ADDENDUM NO. 2

PROJECT: **ADDITION TO THE BLUEBERRY PAVILION
WILMOT ORCHARDS, 3377 CONCESSION RD. 3, CLARINGTON, ONTARIO
PROJECT NO. 19.316**

DATE: June 10, 2020

S-1

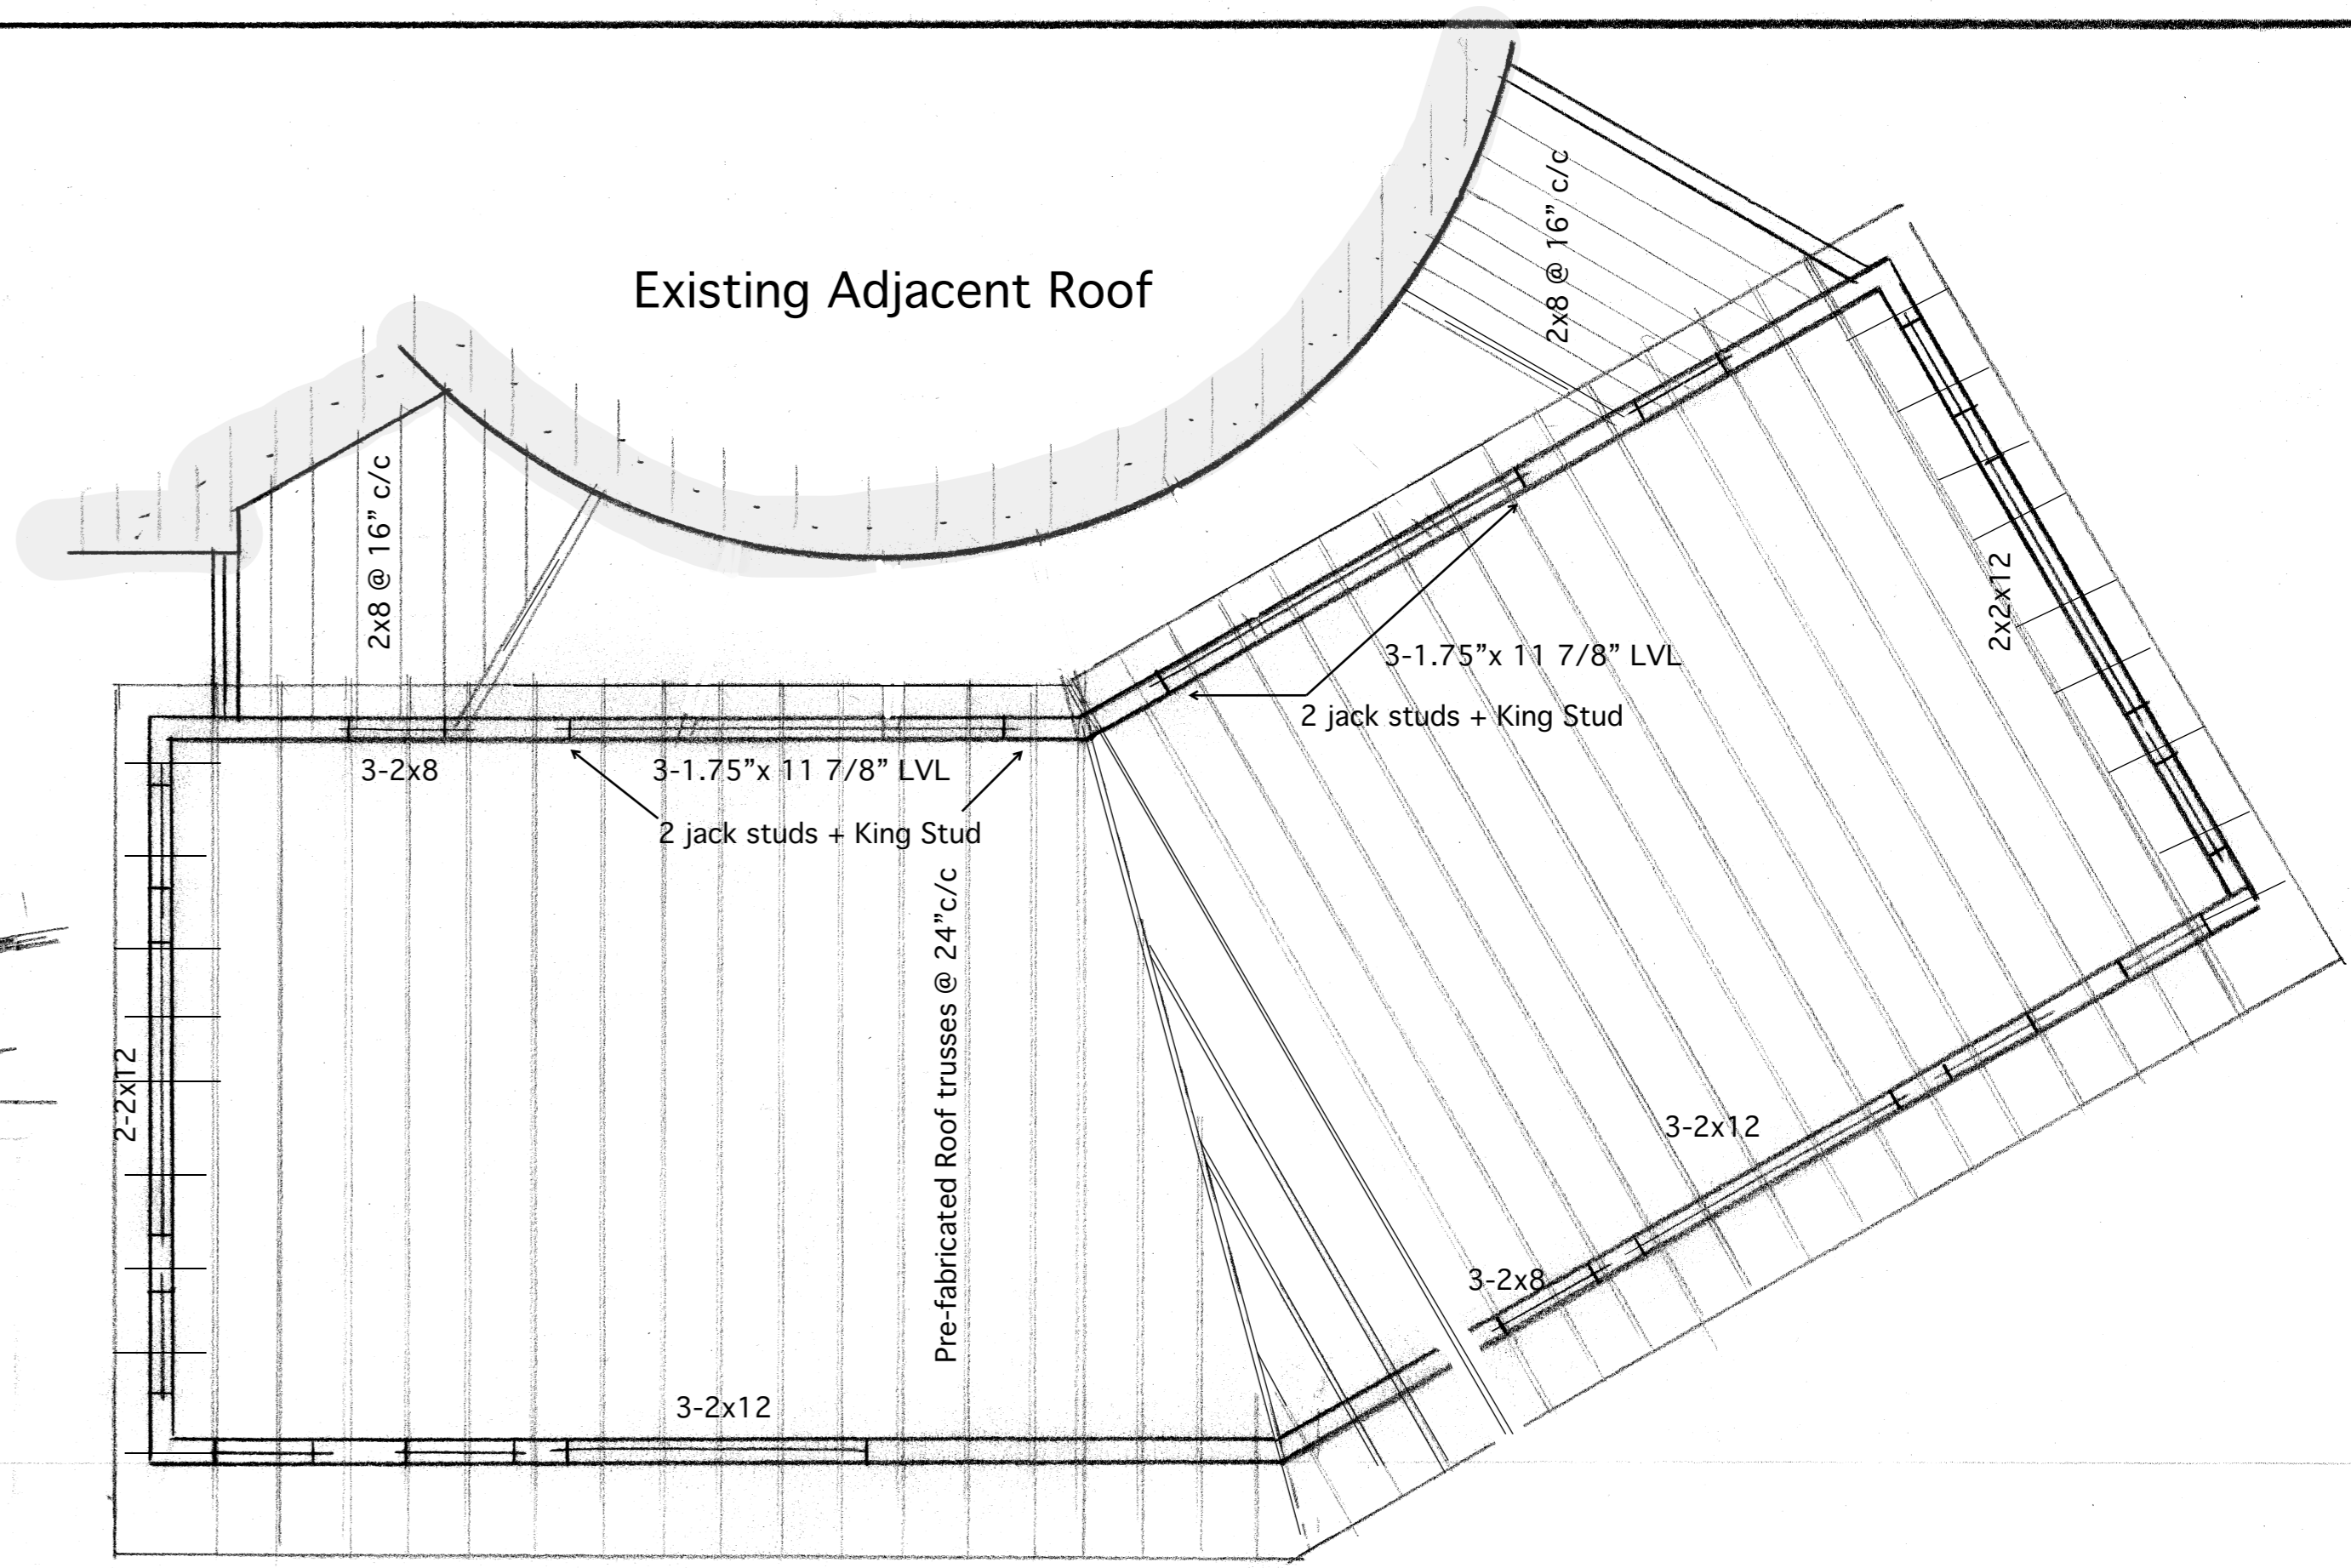
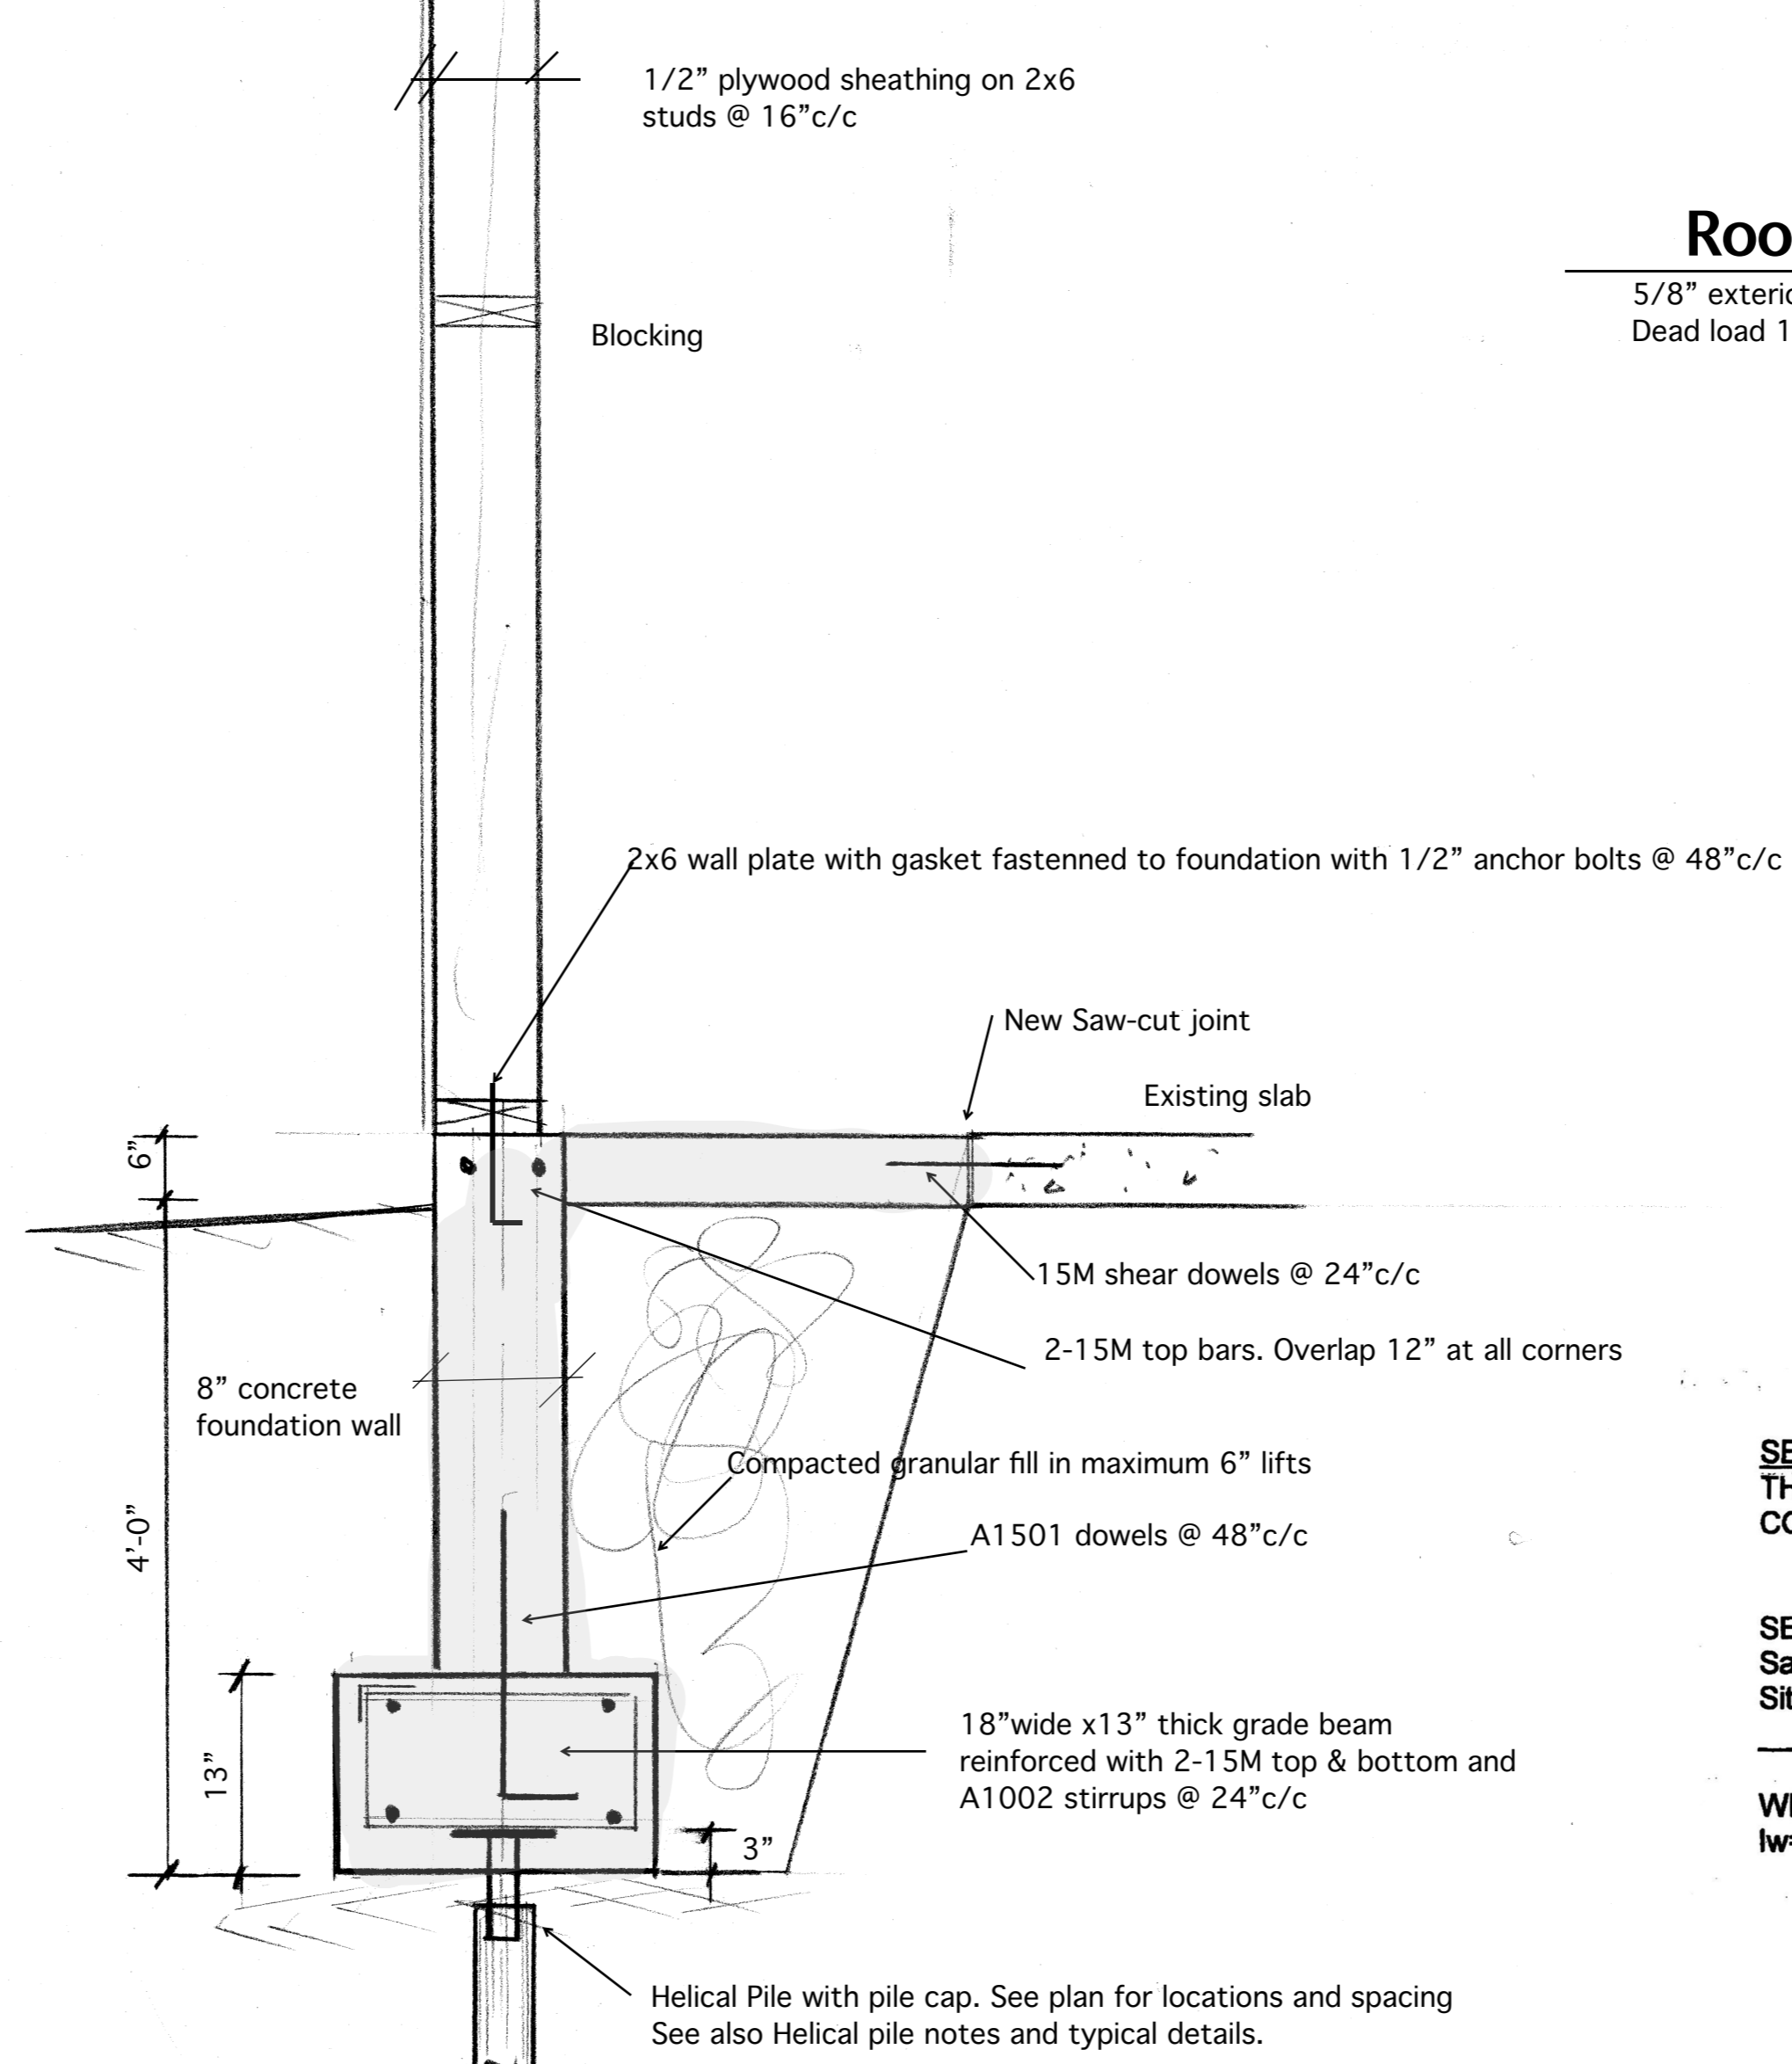
7. Refer to structural drawing S-1, signed and dated January 29, 2020, previously emailed at 9:00 AM on May 19, 2020. Replace this drawing with structural drawing S-1, signed and dated February 11, 2020, and included with this addendum. Note the additional vestibule foundation walls.
